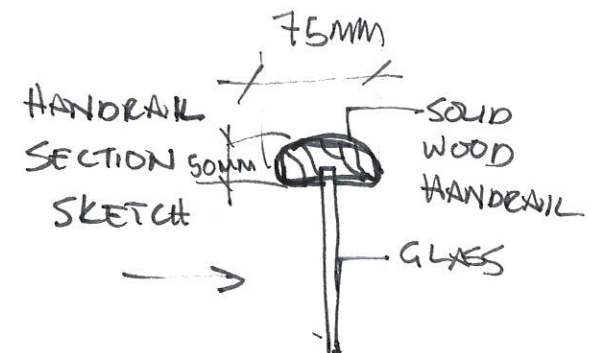
NEW PATTERN FABRIC
FOR ACCENT CUSHIONS
FB.22

L.4 RECESSED BLACK
INTERIOR WITH BLACK
GIMBAL.

WC.2
WRONG WALLCOVERING.

L.2 ALL TRIMLESS,
BLACK GIMBALL

MOVE 1 BACK CUSHION
TO THE SIDE ARM.

F.5 SOFA STYLE IS
WRONG. SEE REFERENCE
IMAGE. ARMS ARE WIDER
& CURVED ON THE INSIDE;
CHROME LEG STYLE (SEE
IMAGE); SEAT CUSHIONS
SHOULD BE "FLUFFY" NOT
FLAT (THINK DOWN-FILLED).
LEFT CHAIR SEAT CUSHION
IS A SINGLE CUSHION, NOT
3 SEPARATE CUSHIONS.

CHANGE F.9
LOUNGE CHAIR FABRIC
TO FB.4

WE ARE CHANGING SOLID
WOOD RAILING TO
A 2" HT. ROUNDED WOOD
HANDRAIL & FRAMELESS
GLASS BELOW.

ARMREST TO HAVE
LEATHER AS PER
IMAGE

DARKER "BURLED" WALNUT
AS PER REFERENCE IMAGE

CHANGE TABLE BASE
TO A TEAL GLASS. SEE
NEW F.10 IMAGE

FL.1 PORCELAIN
3 DIFFERENT TILE SIZES
60x120, 40x80 & 80x80

FRONT LEGS HAVE
BRASS METAL, SAME
AS BACK LEGS.

DROPPED WOOD
BULKHEAD CEILING IN
WD.1

3D DIMENSIONAL TL.1
SEE SAMPLE PROVIDED.

MISSING WOOD
SUSPENDED SCULPTURE
CENTERED ABOVE
CURVED STAIR.

25mm BLACK METAL REVEAL
W/ WOOD BELOW WD.1

DELETE COVE
LIGHTING
